TRI-PARTY AGREEMENT

Change Notice Number TPA-CN- 0795	TPA CHANGE NOTICE FORM	Date: September 12, 2017
Document Number, Title, and Revision: DOE/RL-2009-124, 200 West Pump and Treat Operations and Maintenance Plan, Revision 5		Date Document Last Issued: April 2016
Approved Change Notices Against this Document: TPA-CN-0725, TPA-CN-0759, TPA-CN-0776		
Originator Mark E. Byrnes		Phone: 509 373-3996

Description of Change:
Table B-1 "200 West Area Groundwater Wells", Table B-2 "200 West P&T Wells", Figure B-1 "200 West Groundwater Well Locations", and Figure B-2 "200 West P&T Well Locations and Contaminant Plumes" are revised to include two new injection wells for ZP-1 OU, one new extraction well for UP-1 OU, and one new monitoring well for ZP-1 OU.

Figure B-1. 200 West Groundwater Well Locations

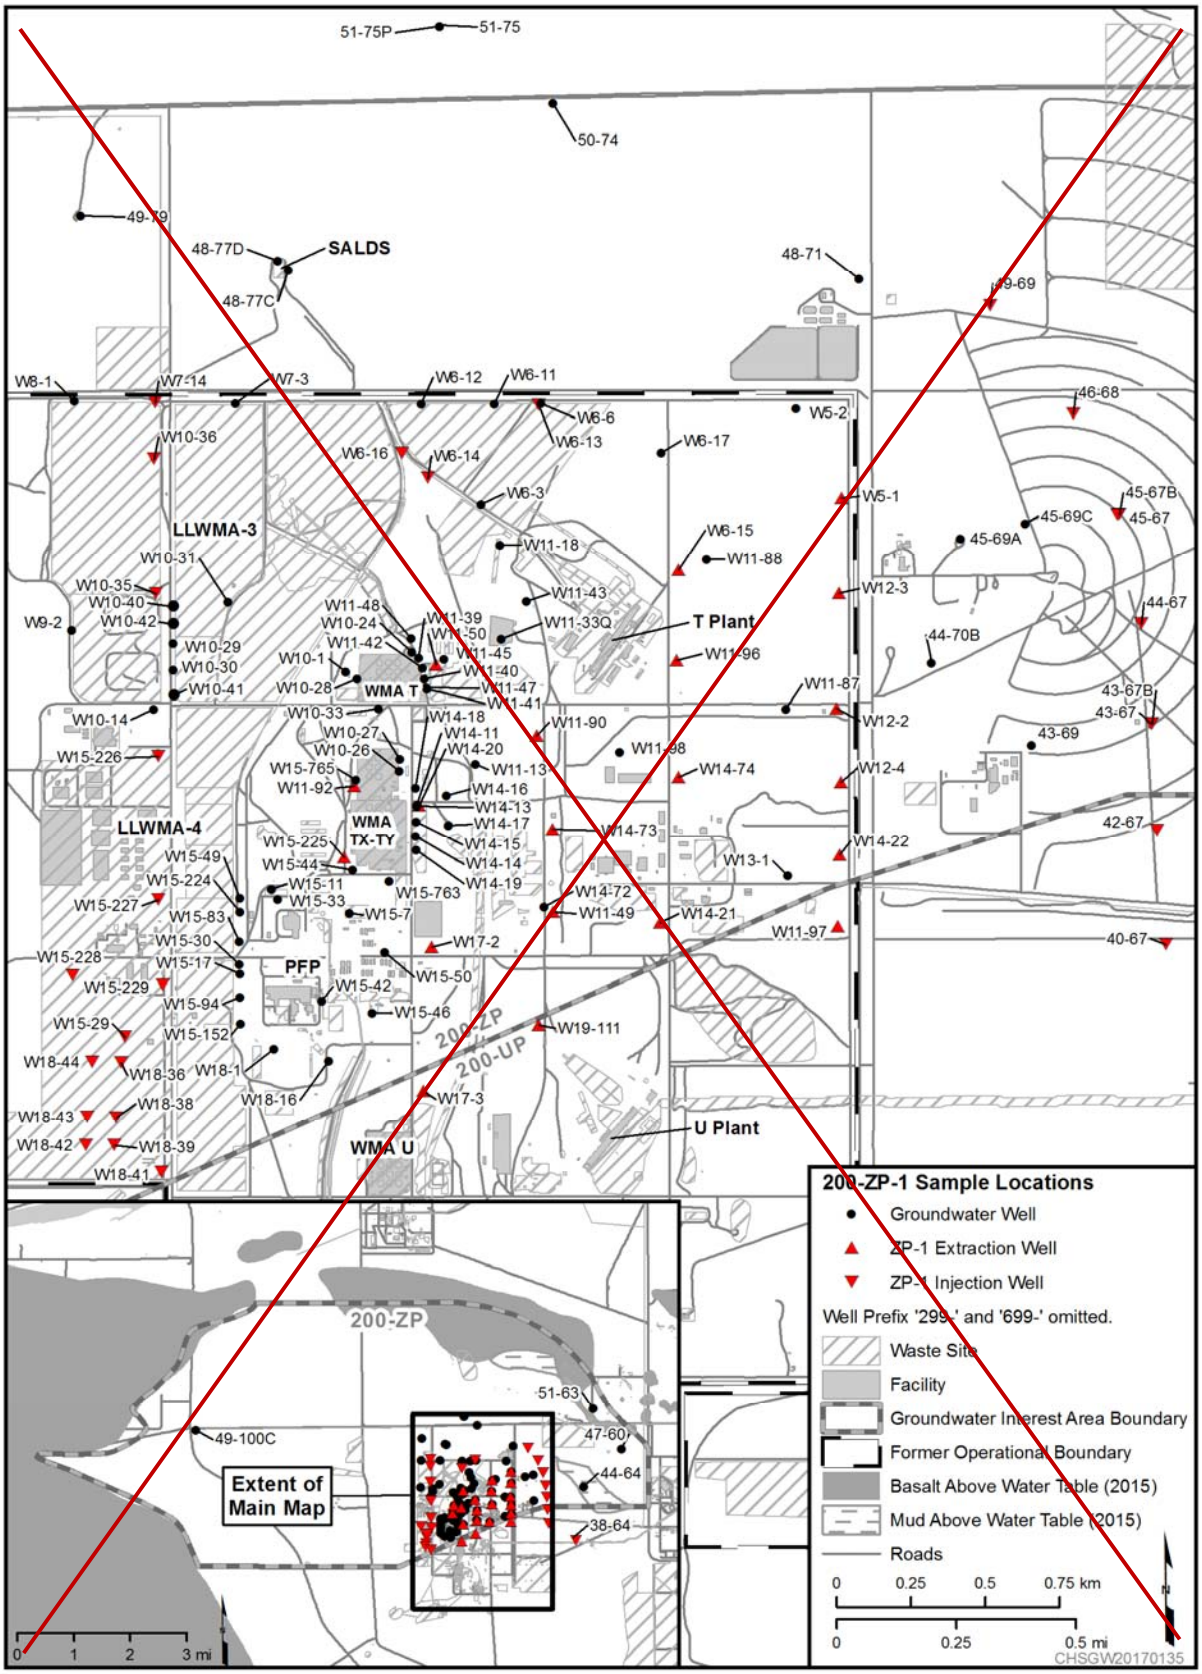
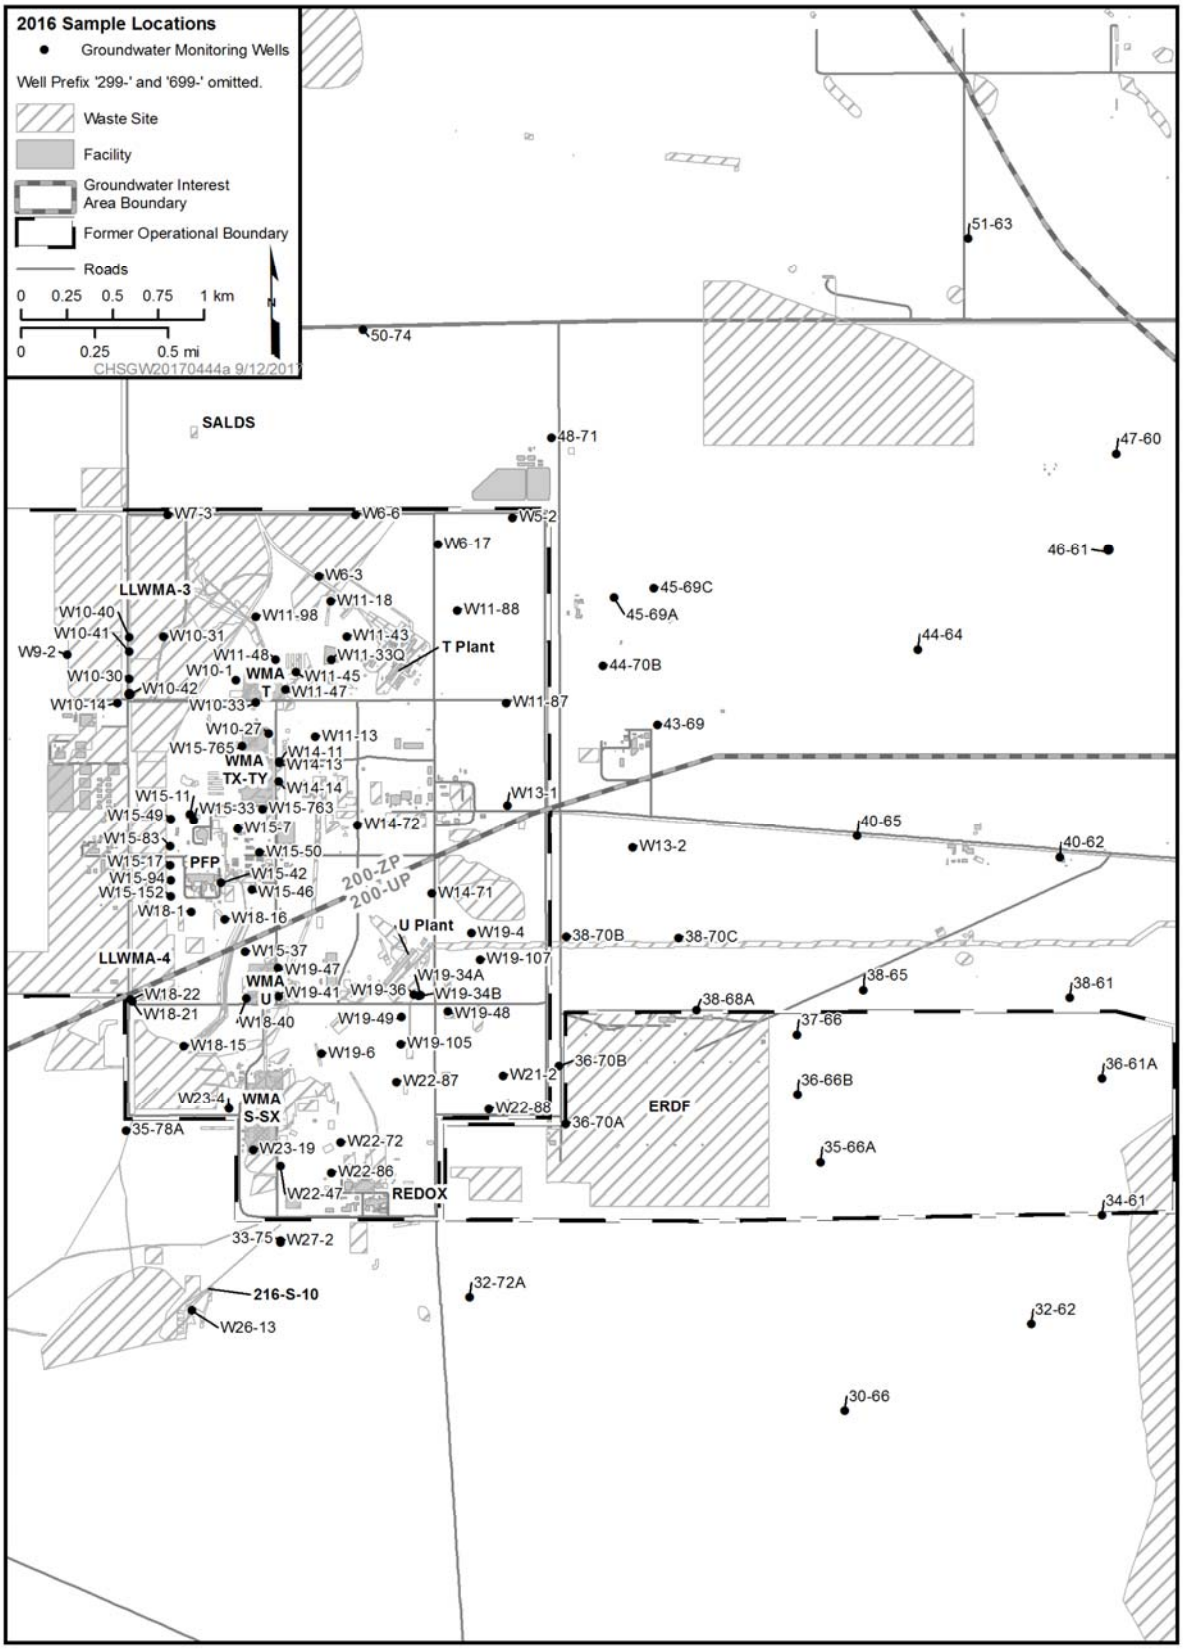
Revised figures and tables to include two new injection wells (YJ-33/C9878/699-47-78 and YJ-34/C9880/699-047-78C), one new extraction well (YE-24/C9594/299-W19-125), and one new monitoring well (C9936/699-46-61).
